UR RESPONSE TO PROVISIONAL DETERMINATION

ANNEX DOCUMENT TO UR-147: DETAILED COMMENTS ON DEFERED CAPEX INCENTIVE

Figure 1: Impact of D3 on NIE T&D Cash Flow

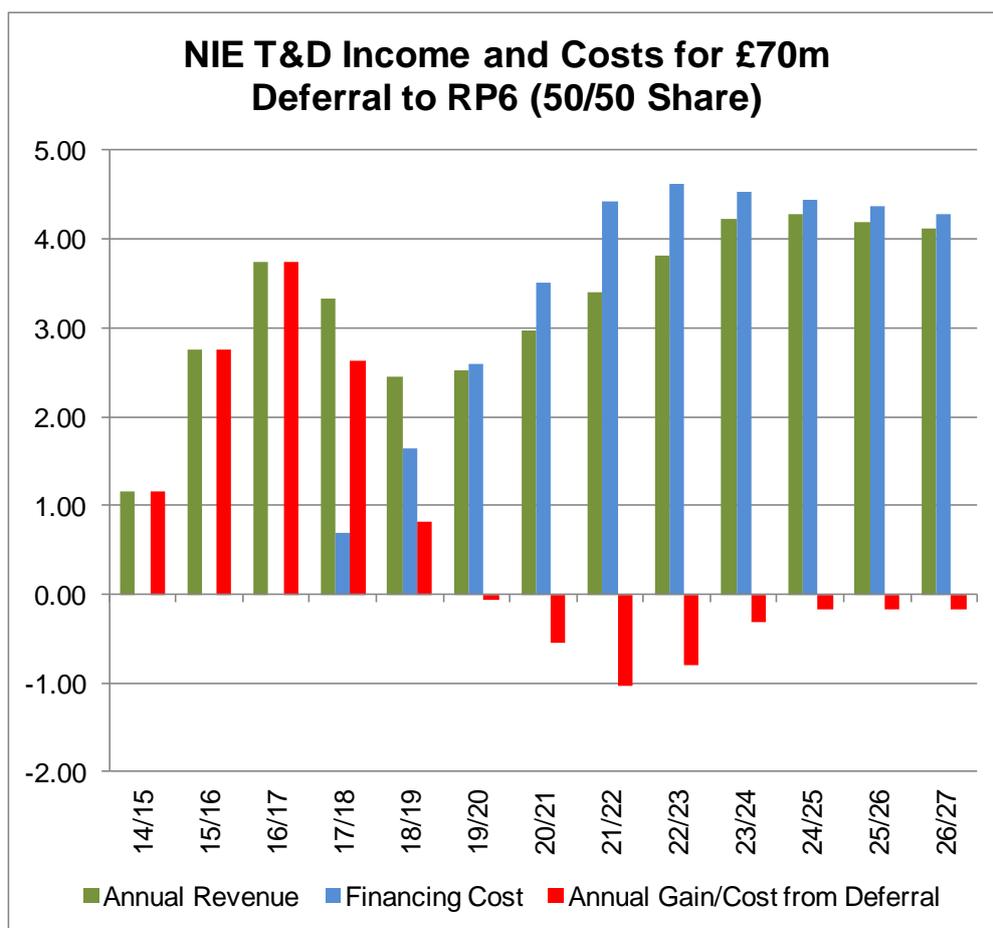
42. The analysis has shown that while NIE T&D benefits from deferring cost under this mechanism in the short term, its costs during RP6 will exceed the revenue received through tariffs. Over the period we have analysed, the NPV benefit to NIE T&D of the cash advance funded through tariffs is at least £7.5 million. This is a material benefit.

43. The results of our analysis are shown in Figure 1 below.

44. This £70 million relates to the direct costs of asset replacement programmes which will need to continue in RP6. It could be interpreted that the challenge that the Commission has now set NIE T&D is to find ways in which to rebrand this work within its business plan for RP6, or inflate the volumes of new work required, to ensure that it can retain up to £35 million of that pot, while customers fund the work again.
